CLOVEWOOD

Final Environmental Impact Statement

Section 10.3 Agency Correspondence

**RE: Clovewood
Village of South Blooming Grove, Orange County
DEC Application ID No. 3-3320-00150/00001,2,3
Notice of Incomplete Application**

Figure - Fallsburg, NY MBR Turbidity Data

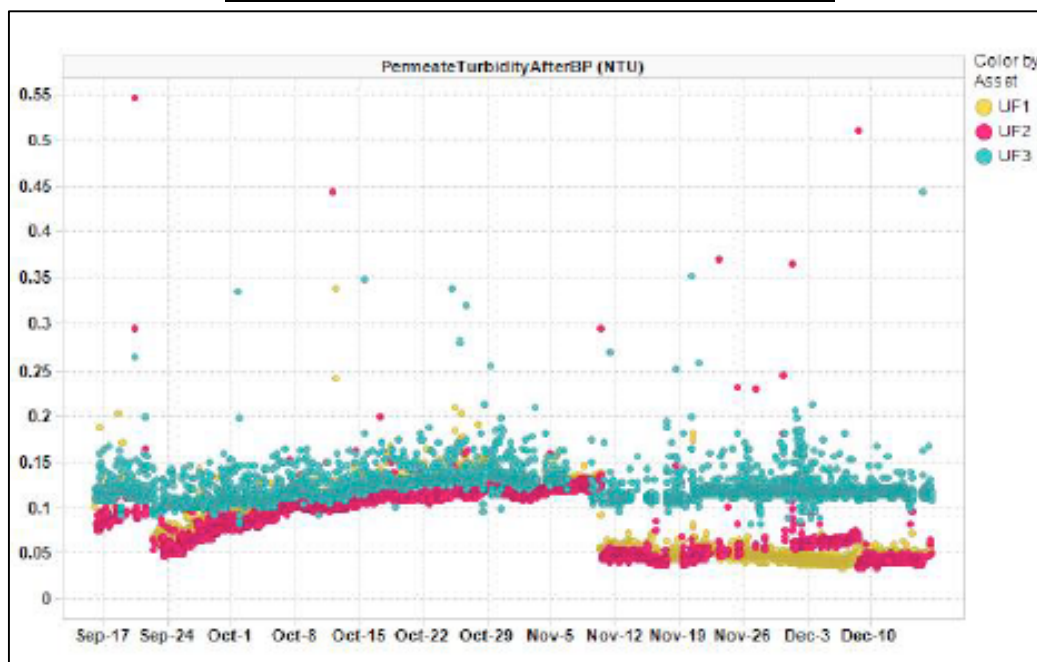
4. Provide technical justification (including data) for the alum outfall concentration on the WTC form to be reduced from 33.14 mg/l to .3314 mg/l.
5. Provide the flow rate associated with the swimming pool filter backwash.

The 33.14 mg/L is an estimated alum concentration for the influent to the proposed MBR treatment microfiltration system and is calculated based on the average flow and dosage (0.28 mgd and 77.4 mg/l dosage). The ZW500d membrane used in the proposed MBR applications has a pore size of 0.04 microns. The ultrafiltration membrane would remove essentially all TSS particulate and colloidal particles larger than the pore size, including precipitates of aluminum sulfate coagulation.

The turbidity results below are provided by SUEZ (MBR manufacturer) for the Fallsburg, NY MBR system for effectiveness of TSS removal. This is the same MBR treatment technology proposed for the Clovewood development. The data was collected between September to December of 2020. Fallsburg has three (3) MBR trains that operate in parallel. As evident by the collected data and provided in the figure below, the turbidity is consistently below 0.2 NTU confirming a high degree of TSS removal by an MBR system.

In addition, MBR modelling completed by SUEZ using EnviroSim Biowin indicates that more than 99% of the alum dose would be reacted with phosphorus as aluminum phosphate and would be removed by the ultrafiltration membranes as waste activated sludge.

Recognizing the pore retention size of the membranes in the MBR system and low turbidity levels demonstrated for a similar system to the one being proposed and the MBR modeling results by SUEZ, the alum concentration being added to precipitate phosphorus is expected to be reduced by at least 99% reducing the feed concentration of 33.14 mg/L to 0.3314 mg/L in the effluent after microfiltration in the MBR system.

Potential Details of Permanent and Temporary Exclusionary Fencing

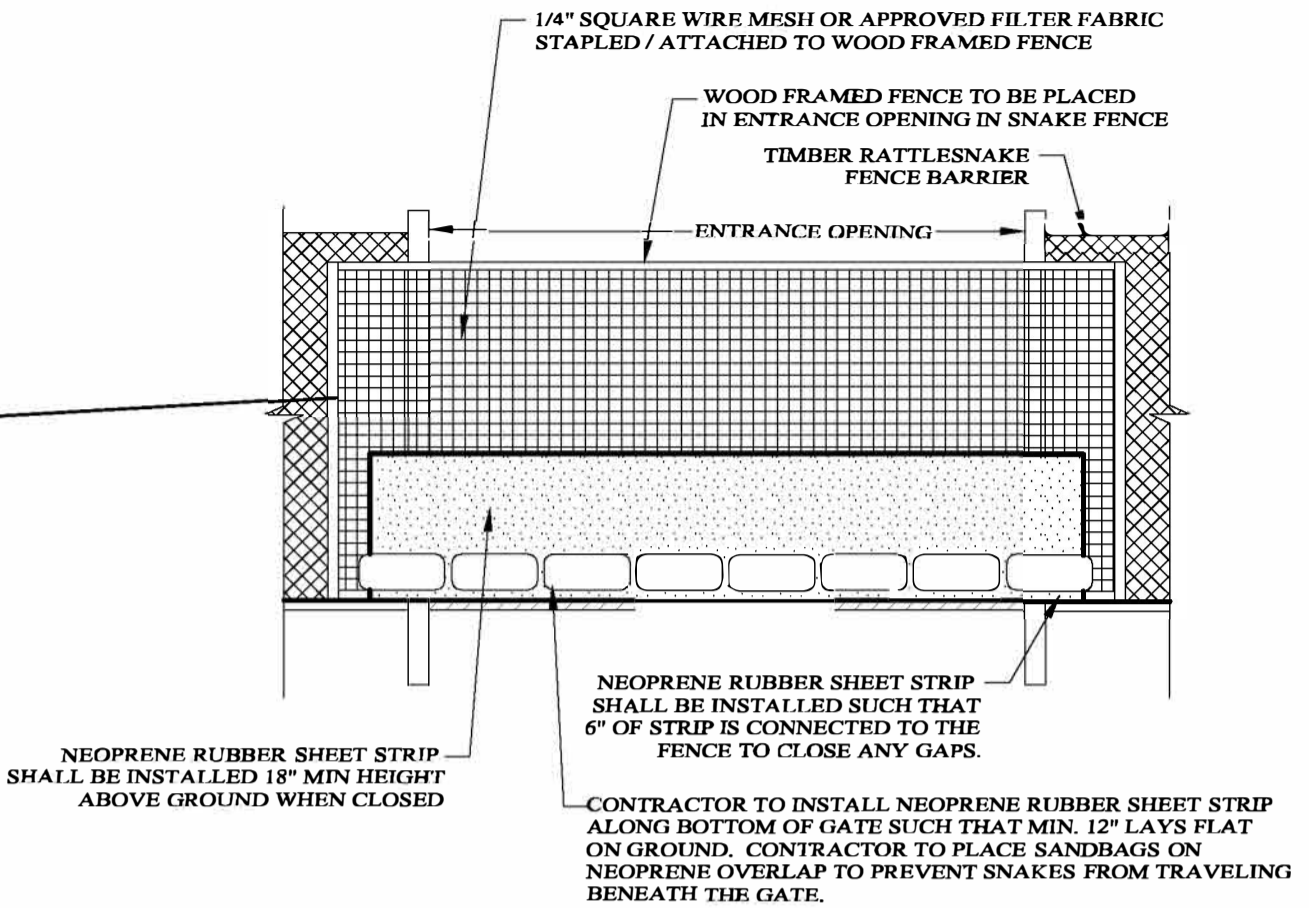
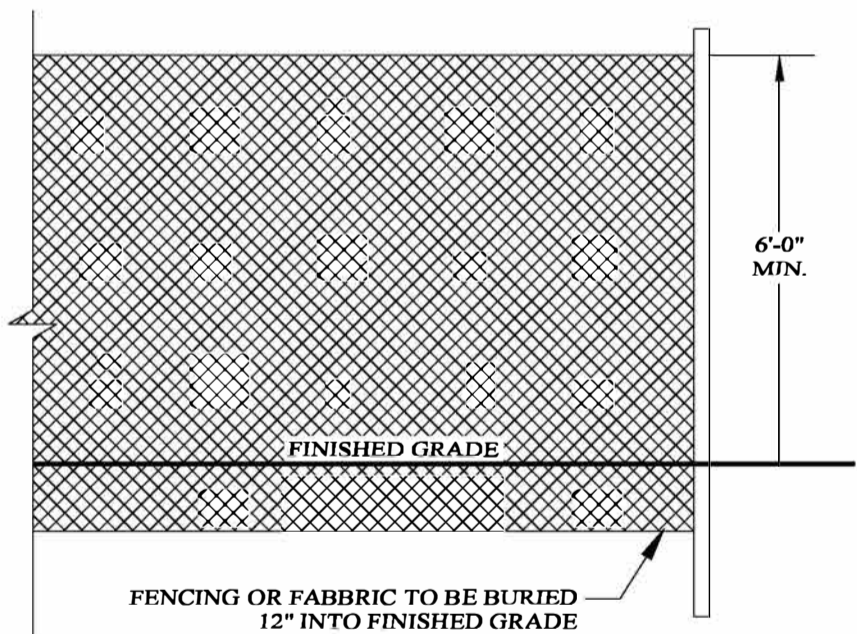
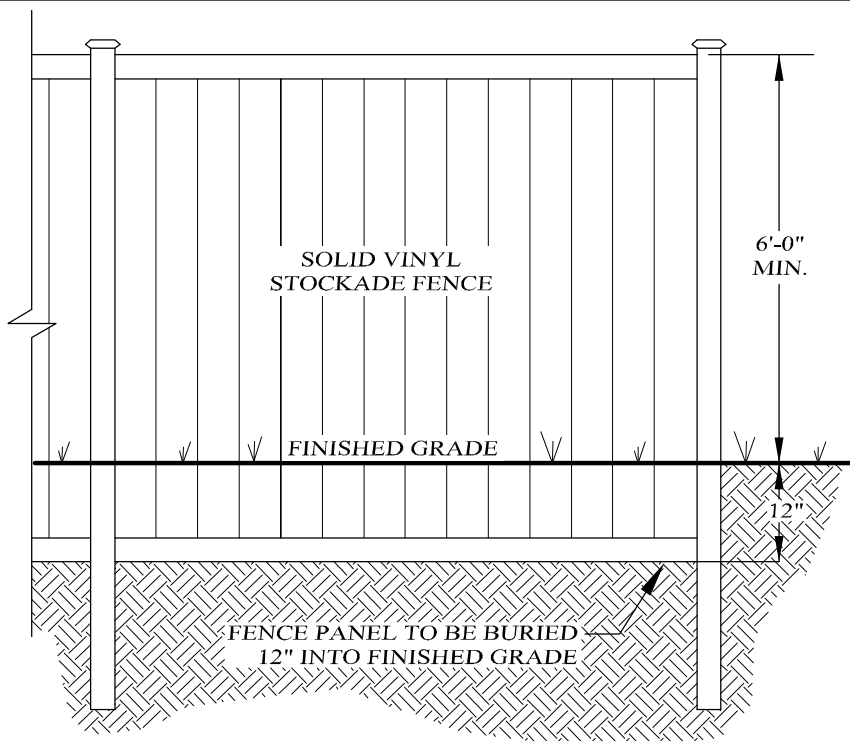
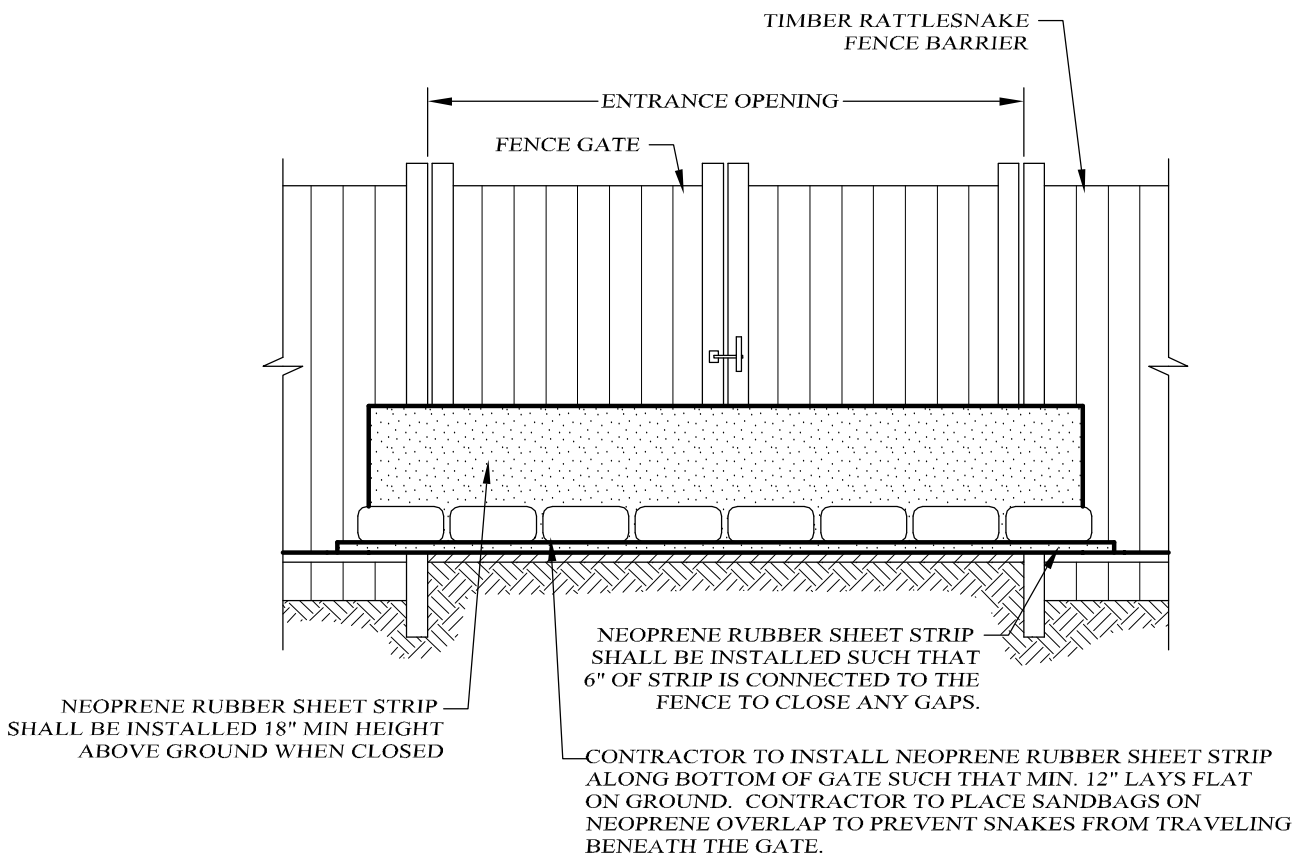
The proposed use of a barrier is discussed in the response letter, but details are not provided on project plans or in the 'Timber Rattlesnake On-Site Contractor BMP's' regarding the installation, material, or maintenance of such a barrier. Please be aware that the Department has modified its preferred barrier fencing guidance, as the Department has assessed implemented take avoidance measures used on previously permitted projects. Based on current information, standard silt fence is not a preferred barrier material for timber rattlesnakes. In addition, given the scale and large size of area requiring fencing, it is not likely to function as intended and will need to be monitored and maintained daily during the active season. While it is mentioned that tree removal would take place from November 1st to March 31st, it is not clear if other land clearing activities will also take place during this time to minimize impacts to timber rattlesnake.

- Attachment 1: Potential Details of Permanent and Temporary Exclusionary Fencing
- Attachment 2: Response Prepared by the Project's hydrogeologist WSP
- Attachment 3: Water Works Formation Documentation
- Attachment 4: Sewage Works Formation Documentation
- Attachment 5: Response Prepared by the Project's wastewater engineer HDR

The Mitigation Plan sets forth measures to be implemented to reduce potential impacts during and after construction including Education and Encounter Plan, Sighting Protocol, Exclusionary Fencing, and Snake Monitor as follows.
